IHE Change Proposal

IHE Domain	Patient Care Device (PCD)
Change Proposal ID:	CP-PCD-145
Change Proposal Status:	Submitted
Date of last update:	2019-09-08
Person assigned:	Monroe Pattillo

Alert Timing Diagram	
Submitter's Name(s) and e-mail address(es):	Monroe Pattillo, monroe.pattillo@gmail.com
Submission Date:	2019-09-05
Integration Profile(s) affected:	Alert Communication Management (ACM)
Actor(s) affected:	Alert Reporter (AR)
IHE Technical Framework or Supplement modified:	ACM profile in PCD TF revision 8.0, dated Oct 23, 2018
Volume(s) and Section(s) affected:	IHE PCD TF Vol 2, section 3.5.4.1.5 Expected Actions

Alert Timing Diagram

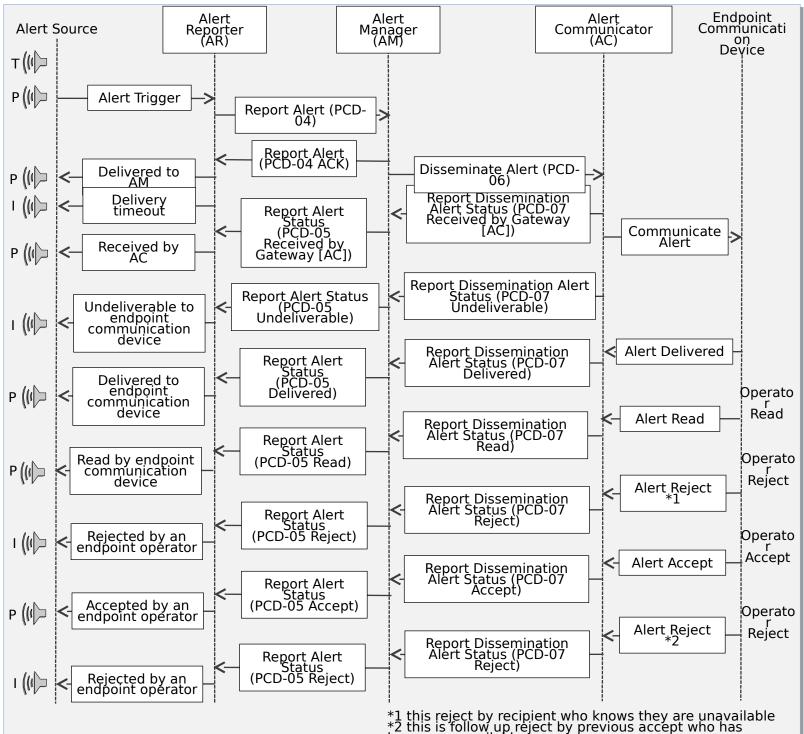
As a part of the Quiet Hospital Working Group (WG) effort a diagram was created and reviewed within that WG and within the Alert Communication Management (ACM) WG. The diagram depicts the alert dissemination progress triggers back to the ACM Alert Reporter (AR) actor for passing to the alert source. This diagram contains consolidated information that is useful to alert sources in deciding whether or not and when to change the state of their local alarm audio without the need for any direct commands from other actors to change the state of the local alarm audio.

This change proposal is to include this diagram in the ACM profile within the PCD Technical Framework (TF) to the end of the section describing AR actor expected actions in response to PCD-05 transactions from the Alert Manager (AM) actor to the AR actor. If the text at the bottom of the diagram is easier to integrate into the section text than to retain it in the diagram that would be acceptable.

Add the below diagram to the end of section 3.5.4.1.5 Expected Actions, page 48, before line 1215
